REAR SUSPENSION

OUTLINE OF CHANGES

GROUP 37

STEERING

STABILIZER BAR**<Hatchback and Sedan-Vehicles for Europe and General Export>****NEW**

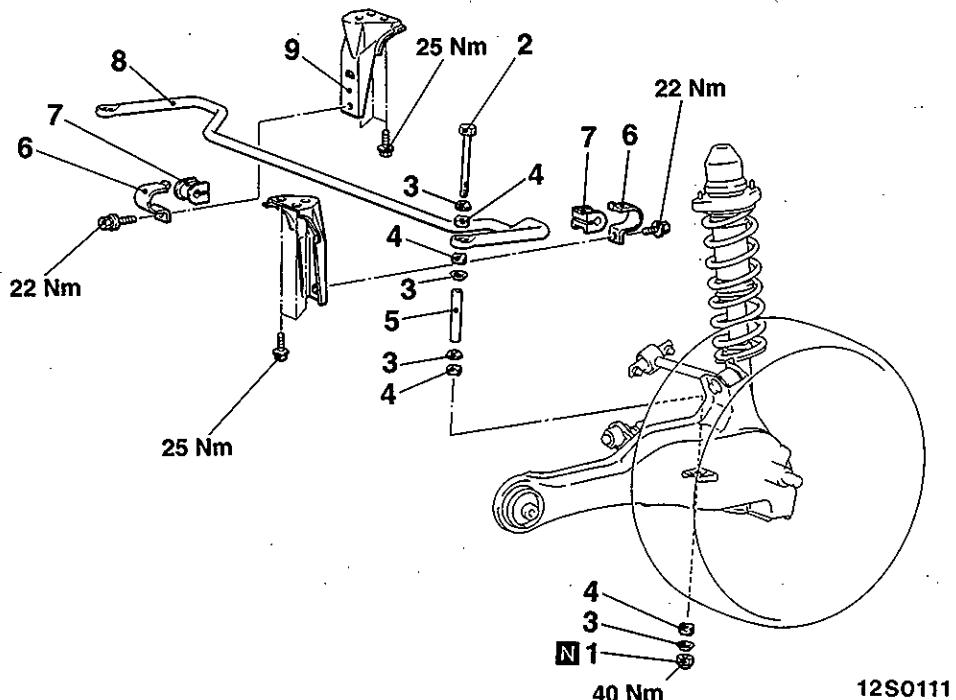
- Coil spring and shock absorber have been changed. <Sedan-4WD for Australia>
- The shape of the stabilizer bar has been changed. Service points of maintenance for the stabilizer bar have been established as a result of this. <Hatchback and Sedan – Vehicles for Europe and General Export>

INSTALLATION SERVICE POINTS**►A◄ STABILIZER BRACKET INSTALLATION**

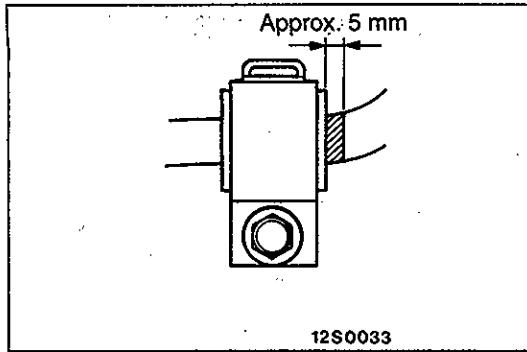
Because the left and right installation positions of the fixtures are different, be careful not to make a mistake when installing the stabilizer bracket.

►B◀ STABILIZER BAR/BUSHING INSTALLATION

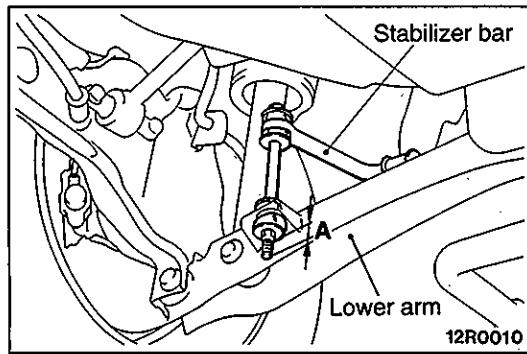
Place the identification mark of the stabilizer bar to the left, and install the bushing so that the identification mark protrudes approximately 5mm from the edge of the inside of the bushing.

POWER STEERING HOSES

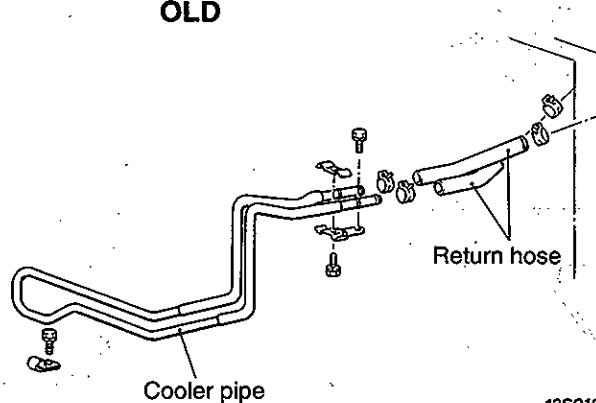
- The cooler pipe has been abolished. The shape of the return hose has been changed because of this. <Except vehicles for Europe (1300 – carburettor, 1500 – carburettor)>
